Subject: Keene Road Disposal Class III Landfill
Application For Class III Landfill Permit
Received August 7, 2000

Subject: Keene Road Disposal Class III Landfill
Application For Class III Landfill Permit
Submitted January 26, 2000

KEENE ROAD DISPOSAL CLASS III LANDFILL
IMPERMEABLE BARRIER LAYOUT

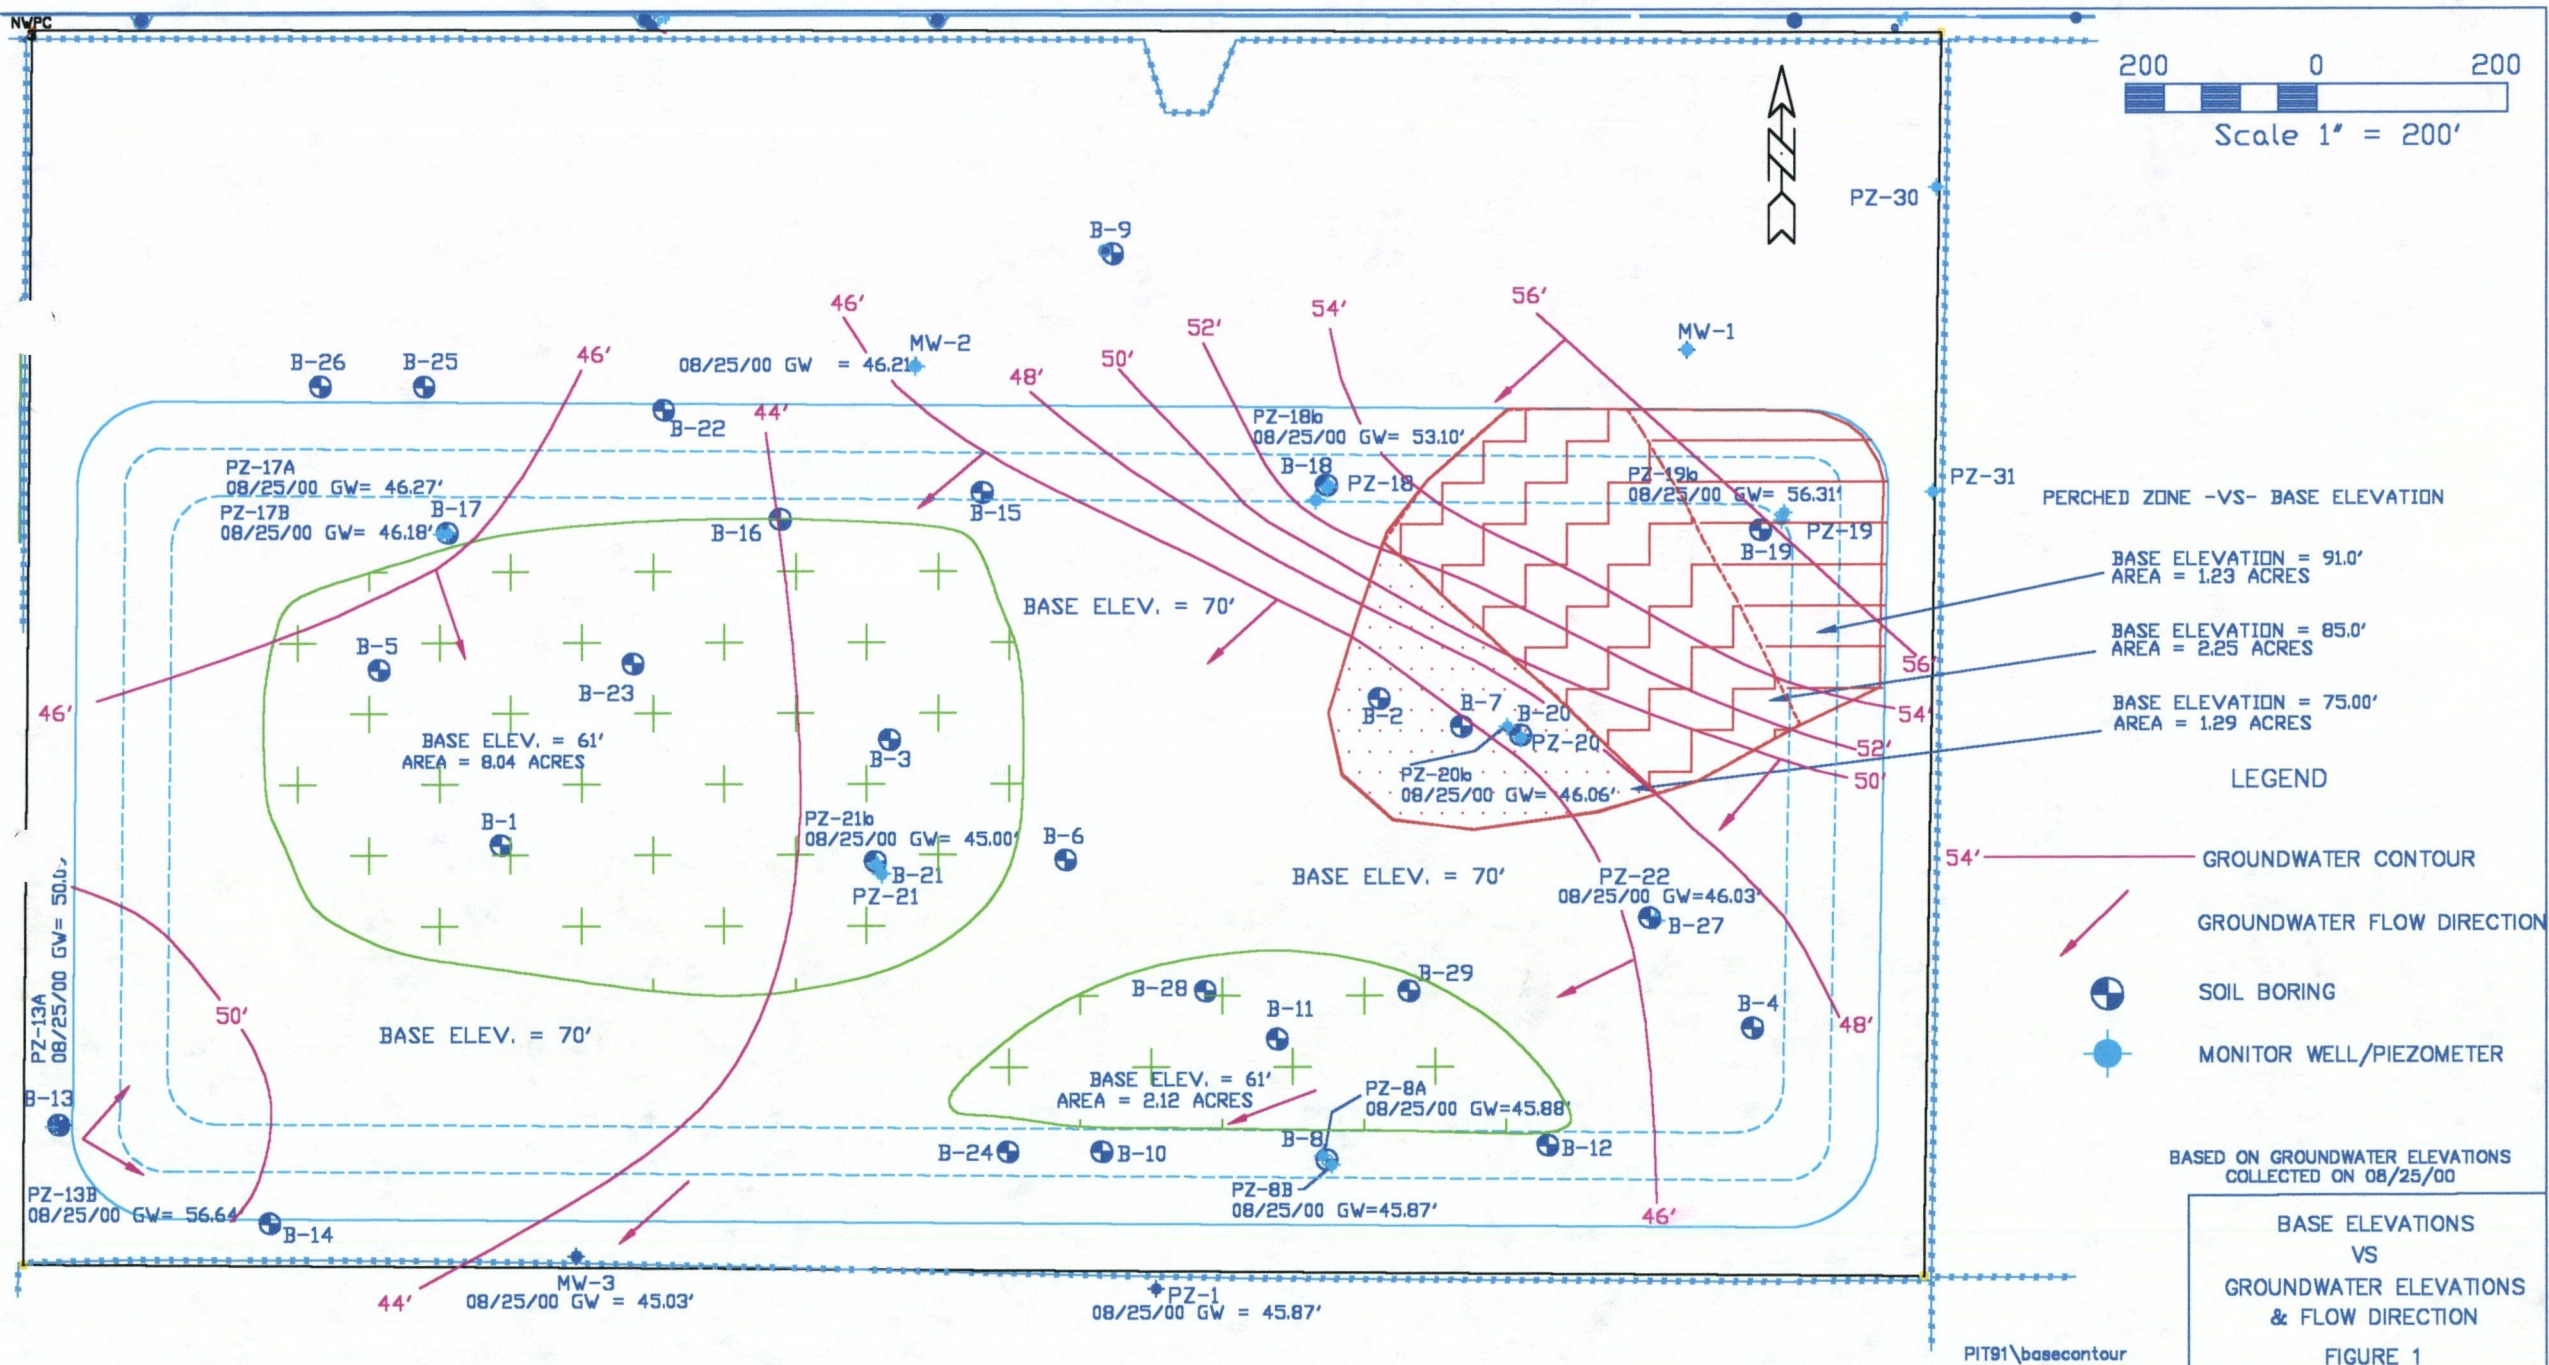
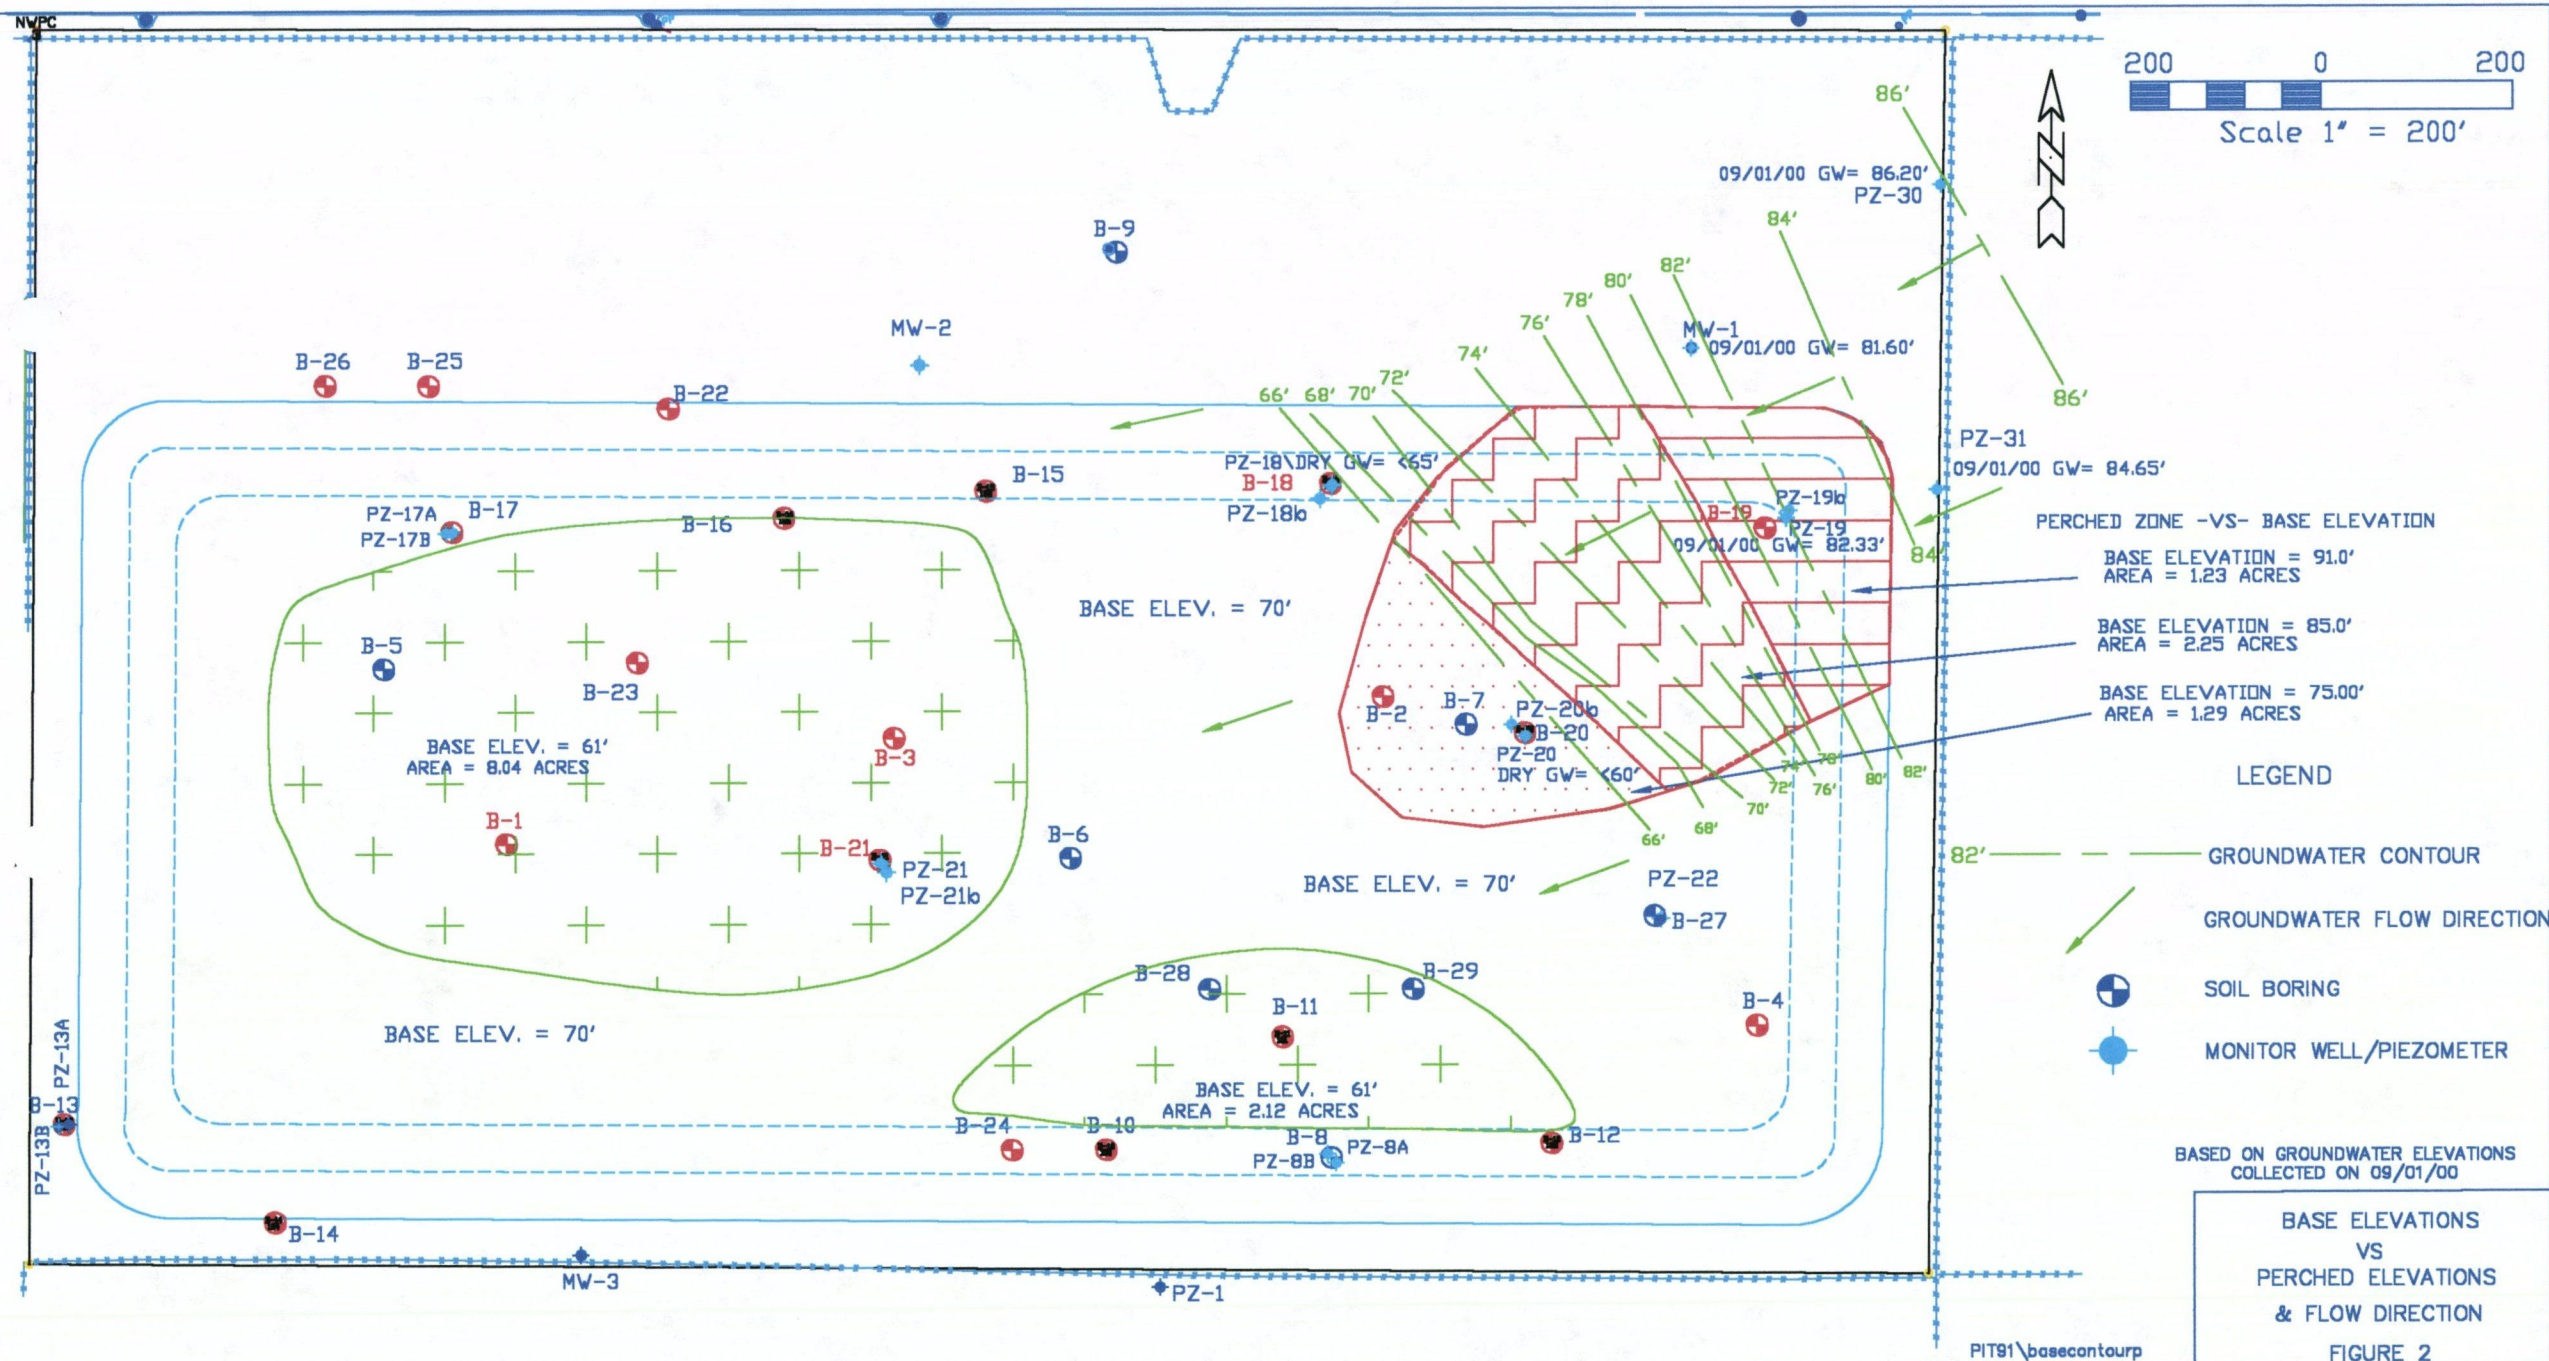
Comment 39: The clay plug concept is unacceptable. The plug cannot be anchored continuously. Following the review of cross sections A-E, it is determined that laboratory tested confining soils are not located in all areas to allow a complete anchor. Perched water contained in soils adjacent to the landfill base grades in the northwest section of the landfill is expected to continue to seep into the landfill following recharge. Sump areas are created in order to allow anchoring into the confining soils. There is a lack of interim stormwater controls. It is doubtful that a 10^{-5} cm/sec liner permeability specification will prevent the groundwater from exceeding MCL standards when tested.

Clear evidence that a bottom liner is unnecessary is not provided. Please propose a design that provides a continuous bottom liner having a maximum permeability of 10^{-7} cm/sec.
